TOWNSHIP OF NORTH DUMFRIES BUILDING DEPARTMENT

These Plans have been examined for Compliance with the Ontario Building Code requirements. A Building Permit has been Issued, subject to any changes noted, under the condition that the building will be constructed in accordance with the code.

Tice River Homes

Legacy

SIGNATURE

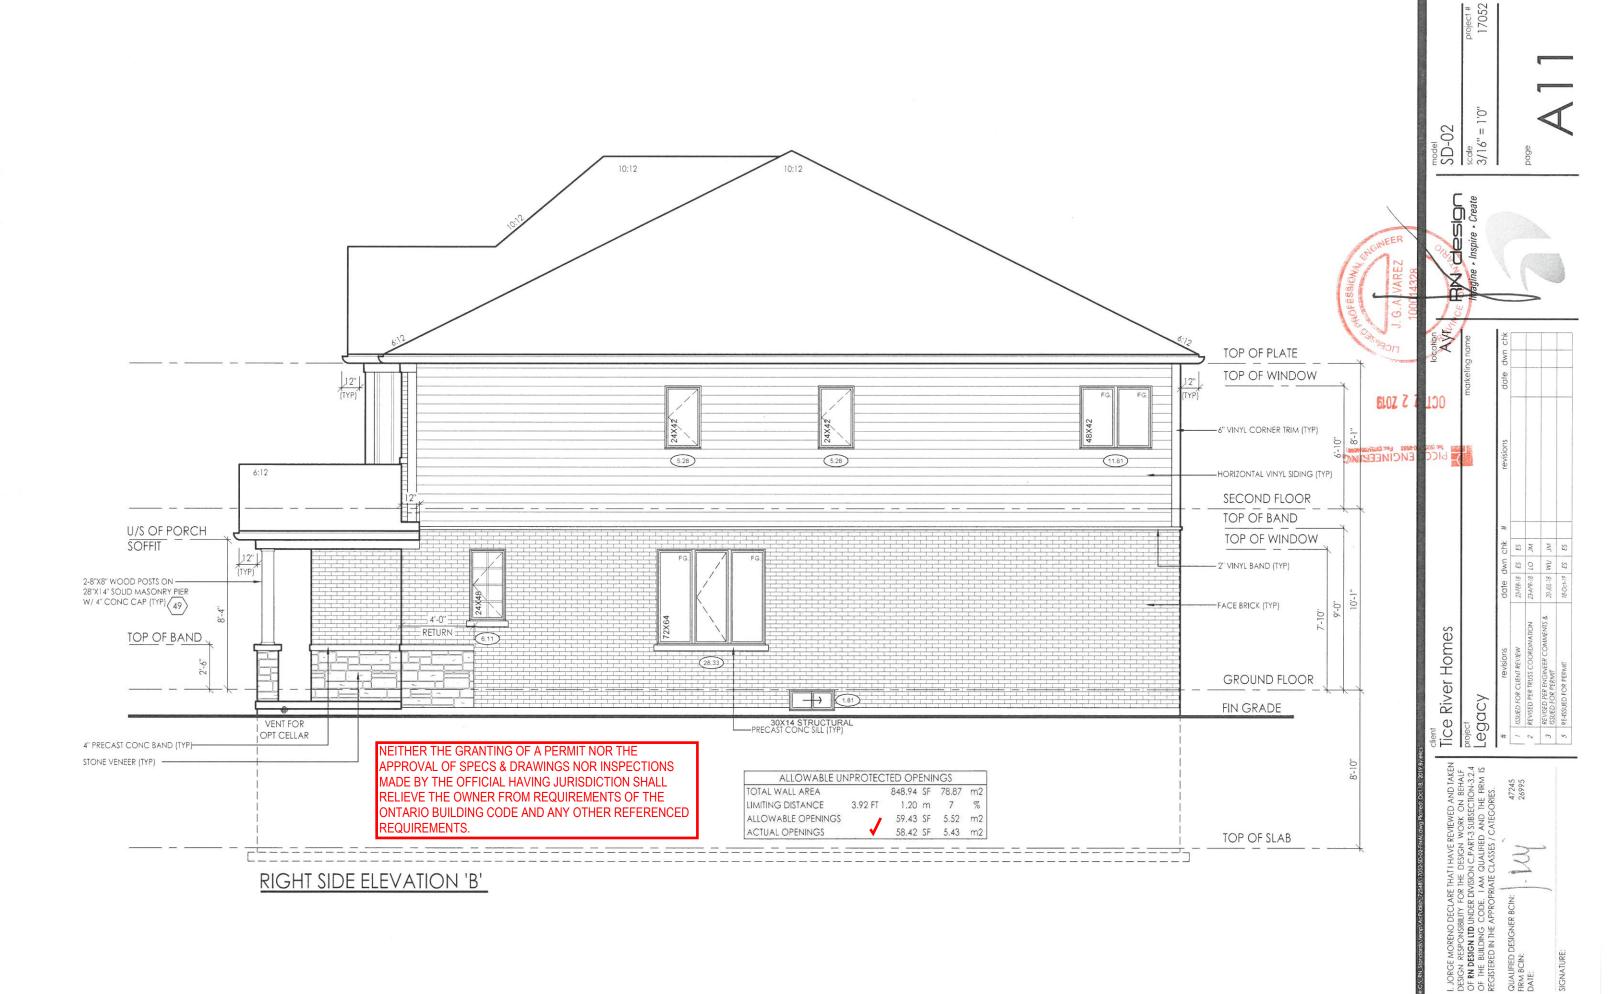
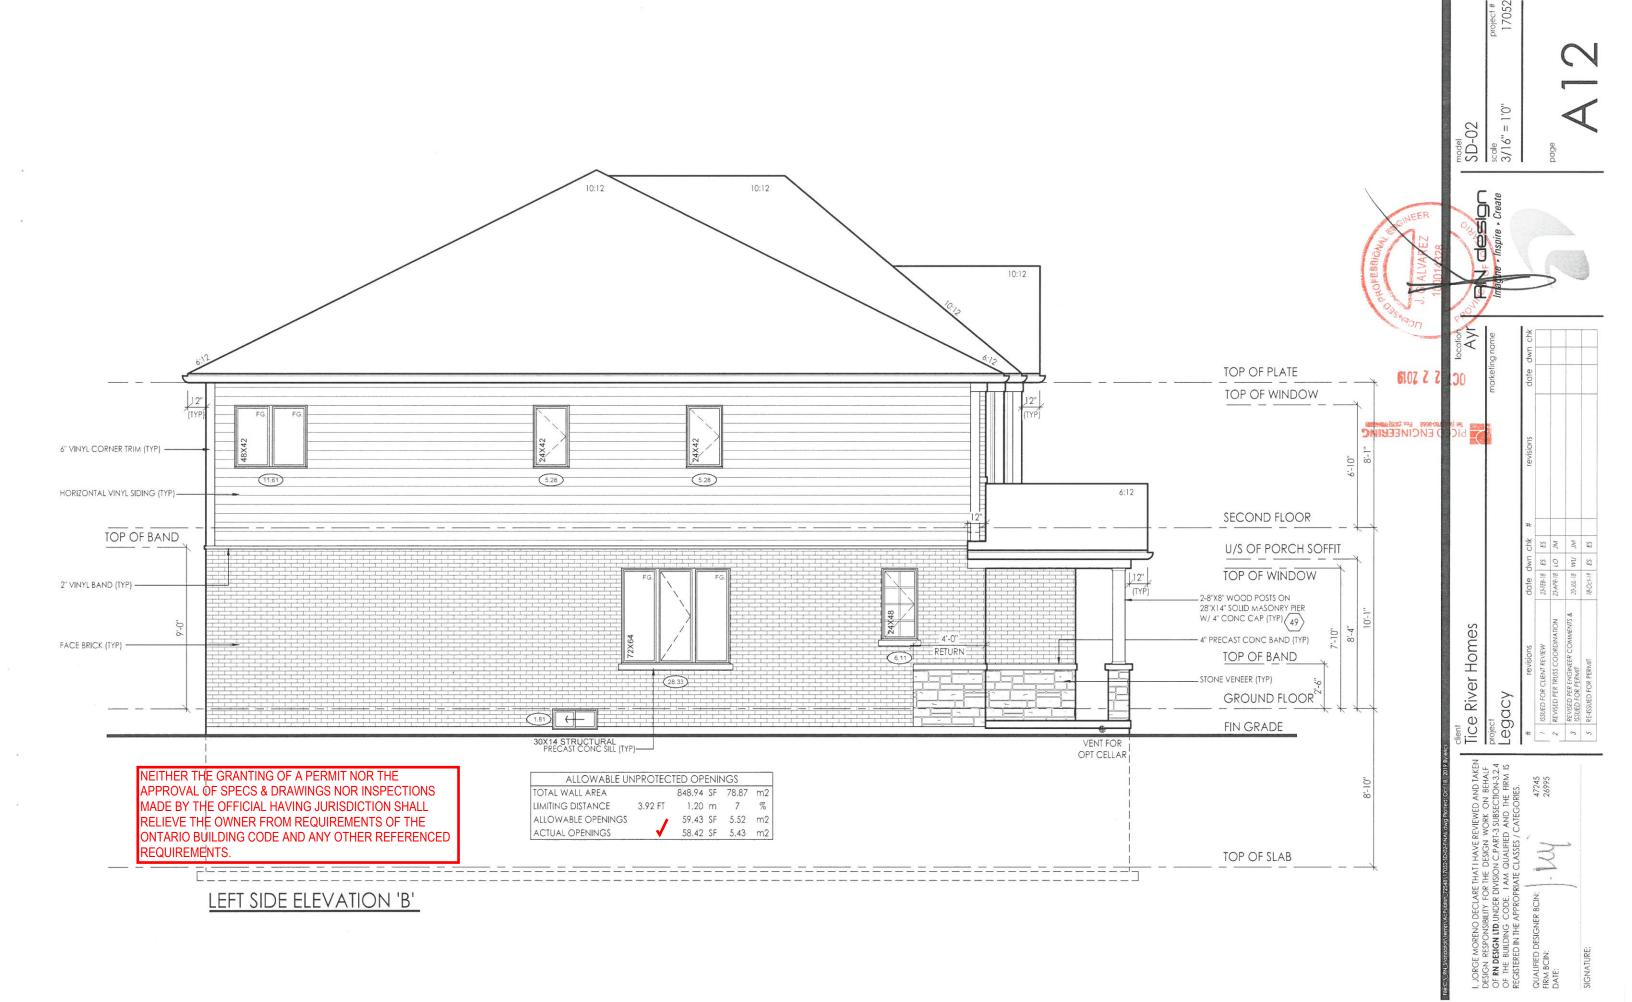
APPROVED DRAWINGS HAVE BEEN RED LINED INDICATING A CHANGE TO MEET THE OBC. PLEASE REVIEW ALL PAGES TO ENSURE YOU ARE PROPERLY INFORMED OF CHANGES.

TIGHTLY FIT ELECTRICAL BOXES WHERE BOXES ARE LOCATED ON BOTH SIDES OF WALL PROVIDING A F.R.R., OFFSET BOXES AT LEAST ONE STD SPACE TO MAINTAIN INTEGRITY OF FIRE SEPARATION.

CALL FOR INSPECTION OF EXCAVATION CRIBBING BEFORE POURING ANY CONCRETE

ANY MODIFICATIONS TO GRADING SHALL NOT ADVERSELY AFFECT **NEIGHBORING PROPERTIES**

INAL GRADING CERTIFICATE REQUIRED BEFORE FINAL **INSPECTION SIGN-OFF**
